Post Approval – Consultation

Post Approval Consultation Record

Jordan Springs Public School

Detailed design road safety audit

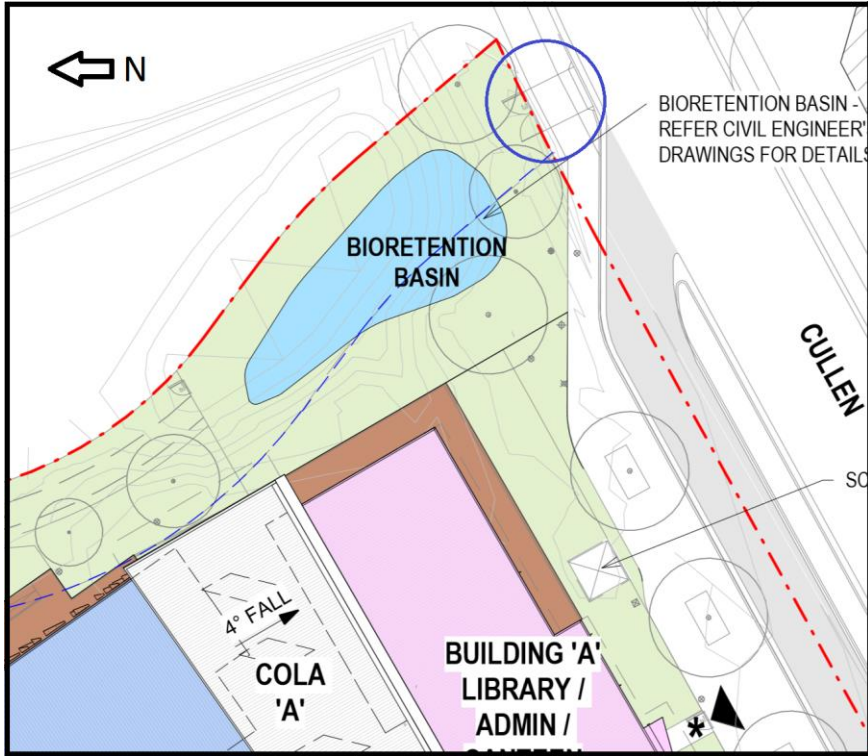
Ref	Location	Road safety audit finding	Priority
4a	Operational impacts of the pick up/ drop off bay on the northern side of Cullen Avenue.	There are likely to be significant queuing and queue-related road safety impacts due to the pick up/ drop off bay. This would be especially during afternoon pick up periods following each school day. The audit team notes the following: - It is assumed that the pick up/ drop off bay will be a one-way <i>eastbound only</i> traffic lane and that all entry would be via the western opening and all egress will be via the eastern opening. Signs and pavement markings should be included, as appropriate, to stipulate this one-way rule and to prohibit entry into the eastern opening. - The pick up/ drop off bay is configured as a <i>left-in only</i> access at its western end and a <i>left-out only</i> egress at its eastern opening. This is considered a reasonably safe layout assuming that all drivers comply with these turn restrictions. Signs and pavement arrows (as appropriate) should be considered to prohibit right-turns into or out of the pick up/ drop off bay. The westbound right-turn into the western opening would be a sharp hairpin turn. Some vehicles may not be able to perform this as a single manoeuvre and may need to resort to three-point turns (including a reversing adjustment with associated crash risks). The right-turn entry movement to the western opening could be a tempting movement since any vehicles that approach from the east would have very few other practical methods of turning around (see item 4b). By contrast the prohibited outbound right-turn movement (from the eastern opening) could be replaced by a left-turn out, and a u-turn at the Alinta Promenade roundabout (further east). Continued in item 4b...  Left: The proposed layout of the pick up/ drop off bay.	Medium

Ref	Location	Road safety audit finding	Priority
4b	Operational impacts of the pick up/ drop off bay on the northern side of Cullen Avenue. Continued from item 4a...	Continued from item 4a... As described in item 4a, the pick up/ drop off bay is configured as a <i>left-in only</i> access at its western end, and a <i>left-out only</i> egress at its eastern end. The inhibited right-turn entry movement at its western end may generate “q-turns” at the Cullen Avenue/ Charlotte Street intersection (ie. a westbound left-turn into Charlotte Street, followed by a u-turn, and followed by a right-turn back into Cullen Avenue such that the entire movement resembles a “q”). Typical “q-turn” movements are illustrated below – including a short “q-turn along the red path and a longer version illustrated by the yellow path. Both of these will generate right-turn movements from Charlotte Street. This would generate crash conflicts with westbound and eastbound vehicular movements on Cullen Avenue. Typically, right-turns from the minor leg of intersections are the most difficult turning manoeuvres since there are gap acceptance (and hence gap-checking) requirements in both major road flows. The short “q-turn” path illustrated by the red arrow also introduces a u-turn in the control area of the intersection which could have its own crash conflicts such as with vehicles turning into or out of Charlotte Street. Consideration may be needed for signposted time-based prohibitions (bans) on right-turns from Charlotte Street during school zone periods.  Left: With no other restrictions in place, the audit team envisages that Charlotte Street will be used by westbound drivers to perform “q-turns” to access the pick up/ drop off bay in lieu of the likely prohibited right-turn entry to the bay.	Medium

Ref	Location	Road safety audit finding	Priority
4c	Operational impacts of the pick up/ drop off bay on the northern side of Cullen Avenue. Continued from item 4b...	Continued from item 4b... Queue management is especially critical to the road safety performance of the pick up/ drop off bay, especially during afternoon pick up periods. If the pick up operations are untidy and cause queuing, these queues could easily spill back out of the pick up bay and into Cullen Avenue, where the back of queue would be exposed to <i>rear-end</i> crashes. The queue may also spill back to and across the zebra crossing. This is largely a traffic management issue during the operational phase. However, there are some design measures that could be used to mitigate these risks. Simple linemarking solutions in the pick up bay could be used to guide drivers where to queue and where to stop to pick up students. This would also create a wide residual space for other vehicles (that have completed their pick up “transactions”) to pass around other vehicles that are still loading. The audit team notes that the long pick-up rank and kerbline must be managed diligently to operate efficiently. Firstly, in order for the pick up zone to be used efficiently, the student would need to predict which part of the pick up bay their parent/ carer will arrive at. Unless this can happen, there will always be several pick up spaces that students will take substantially longer to reach from their dispatch point. Using the top image, if the student dispatch point is at Y, then the student will take longer to reach their parent/ carer’s car in spaces G, H and I and hence these cars will be delayed much more than those in the leading spaces. Similarly, if the student dispatch point is midway along the bay, then cars in spaces A, B and C would experience more delays compared with the trailing bays. The differential waiting times across the pick up rank would lead to different “transaction” times which means the fully occupied rank cannot move off in a single platoon. Rather, cars will leave the rank as they complete their transaction, not when ALL other cars in the rank have completed their transactions. There would be a mixture of occupied spaces and vacant spaces since the spaces will not all vacate at the same time. The top image also shows what would happen when cars in spaces A, B and C are still completing pick up operations and another car (red vehicle) arrives at the rank, this vehicle would enter bay D instead of waiting until A, B and C become vacant. The bottom image shows what happens next after vehicles A, B and C vacate the rank. The next vehicle that arrives would typically enter space E rather than cutting in front of car D to access A, B or C. Hence the storage capacity of the rank diminishes due to the inefficient loading and transactions. Alternatively, if the green vehicle does head towards A, B or C they could generate a <i>cross over</i> crash conflict with the red vehicle as it pulls out. In the audit team’s experience with other schools, a long-rank style pick up zone works best if the pick up operations are confined to the first few spaces (say A to C), and the remaining spaces are only used as a lead-up queue. The children would be dispatched from point Y which therefore limits the longest walk-distance to the Y-C distance. Although this is a traffic management decision, the design could assist by creating more road-side waiting space, and perhaps shelter at the leading portion of the bay to encourage all loading to occur at this end of the bay.  Top and bottom: A typical scenario that would occur at a long-rank style pick up zone. Descriptions are provided in the body text.	Medium

4a	Operational impacts of the pick up/ drop off bay on the northern side of Cullen Avenue.	There are likely to be significant queuing and queue-related road safety impacts due to the pick up/ drop off bay. This would be especially during afternoon pick up periods following each school day. The audit team notes the following: - It is assumed that the pick up/ drop off bay will be a one-way <i>eastbound only</i> traffic lane and that all entry would be via the western opening and all egress will be via the eastern opening. Signs and pavement markings should be included, as appropriate, to stipulate this one-way rule and to prohibit entry into the eastern opening. - The pick up/ drop off bay is configured as <i>left-in only</i> access at its western end and <i>left-out only</i> egress at its eastern opening. This is considered a reasonably safe layout assuming that all drivers comply with these turn restrictions. Signs and pavement arrows (as appropriate) should be considered to prohibit right-turns into or out of the pick up/ drop off bay. The westbound right-turn into the western opening would be a sharp hairpin turn. Some vehicles may not be able to perform this as a single manoeuvre and may need to resort to three-point turns (including a reversing adjustment with associated crash risks). The right-turn entry movement to the western opening could be a tempting movement since any vehicles that approach from the east would have very few other practical methods of turning around (see item 4b). By contrast the prohibited outbound right-turn movement (from the eastern opening) could be replaced by a left-turn out, and a u-turn at the Alinta Promenade roundabout (further east). Continued in item 4b... Below: The proposed layout of the pick up/ drop off bay. 	Medium	Signage & line marking has been incorporated into the kiss & drop as recommended by the auditor to ensure that the bay operates in a single direction only.

4b	Operational impacts of the pick up/ drop off bay on the northern side of Cullen Avenue. Continued from item 4a...	Continued from item 4a... As described in item 4a, the pick up/ drop off bay is configured as <i>a left-in only</i> access at its western end, and <i>a left-out only</i> egress at its eastern end. The inhibited right-turn entry movement at its western end may generate "q-turns" at the Cullen Avenue/ Charlotte Street intersection (ie. a westbound left-turn into Charlotte Street, followed by a u-turn, and followed by a right-turn back into Cullen Avenue such that the entire movement resembles a "q"). Typical "q-turn" movements are illustrated below – including a short "q-turn" along the red path and a longer version illustrated by the yellow path. Both of these will generate right-turn movements from Charlotte Street. This would generate crash conflicts with westbound and eastbound vehicular movements on Cullen Avenue. Typically, right-turns from the minor leg of intersections are the most difficult turning manoeuvres since there are gap acceptance (and hence gap-checking) requirements in both major road flows. The short "q-turn" path illustrated by the red arrow also introduces a u-turn in the control area of the intersection which could have its own crash conflicts such as with vehicles turning into or out of Charlotte Street. Consideration may be needed for signposted time- based prohibitions (bans) on right-turns from Charlotte Street during school zone periods. <i>Left: With no other restrictions in place, the audit team envisages that Charlotte Street will be used by westbound drivers to perform "q-turns" to access the pick up/ drop off bay in lieu of the likely prohibited right-turn entry to the bay.</i> 	Medium	Additional signage and line marking will be installed at the intersection of Cullen Avenue & Charolette Street to ensure that all road users are aware which traffic is has right of way (Cullen Avenue)

4c	Operational impacts of the pick up/ drop off bay on the northern side of Cullen Avenue. Continued from item 4b...	Continued from item 4b... Queue management is especially critical to the road safety performance of the pick up/ drop off bay, especially during afternoon pick up periods. If the pick up operations are untidy and cause queuing, these queues could easily spill back out of the pick up bay and into Cullen Avenue, where the back of queue would be exposed to<i>near-end</i> crashes. The queue may also spill back to and across the zebra crossing. This is largely a traffic management issue during the operational phase. However, there are some design measures that could be used to mitigate these risks. Simple linemarking solutions in the pick up bay could be used to guide drivers where to queue and where to stop to pick up students. This would also create a wide residual space for other vehicles (that have completed their pick up "transactions") to pass around other vehicles that are still loading. The audit team notes that the long pick-up rank and kerblines must be managed diligently to operate efficiently. Firstly, in order for the pick up zone to be used efficiently, the student would need to predict which part of the pick up bay their parent/ carer will arrive at. Unless this can happen, there will always be several pick up spaces that students will take substantially longer to reach from their dispatch point. Using the left image, if the student dispatch point is at Y, then the student will take longer to reach their parent/ carer's car in spaces G, H and I and hence these cars will be delayed much more than those in the leading spaces. Similarly, if the student dispatch point is midway along the bay, then cars in spaces A, B and C would experience more delays compared with the trailing bays. The differential waiting times across the pick up rank would lead to different "transaction" times which means the fully occupied rank cannot move off in a single platoon. Rather, cars will leave the rank as they complete their transaction, not when ALL other cars in the rank have completed their transactions. There would be a mixture of occupied spaces and vacant spaces since the spaces will not all vacate at the same time. The top image also shows what would happen when cars in spaces A, B and C are still completing pick up operations and another car (red vehicle) arrives at the rank, this vehicle would enter bay D instead of waiting until A, B and C become vacant. The bottom image shows what happens next after vehicles A, B and C vacate the rank. The next vehicle that arrives would typically enter space E rather than cutting in front of car D to access A, B or C. Hence the storage capacity of the rank diminishes due to the inefficient loading and transactions. Alternatively, if the green vehicle does head towards A, B or C they could generate an<i>an</i> over-crash conflict with the red vehicle as it pulls out. In the audit team's experience with other schools, a long-rank style pick up zone works best if the pick up operations are confined to the first few spaces (say A to C), and the remaining spaces are only used as a lead-up queue. The children would be dispatched from point which therefore limits the longest walk-distance to the Y-C distance. Although this is a traffic management decision, the design could assist by creating more road-side waiting space, and perhaps shelter at the leading portion of the bay to encourage all loading to occur at this end of the bay. <i>Top and bottom: A typical scenario that would occur at a long-rank style pick up zone. Descriptions are provided in the body text.</i> 	Medium	The school operations team will actively manage the operation of the kiss & drop bay during peak usage periods.
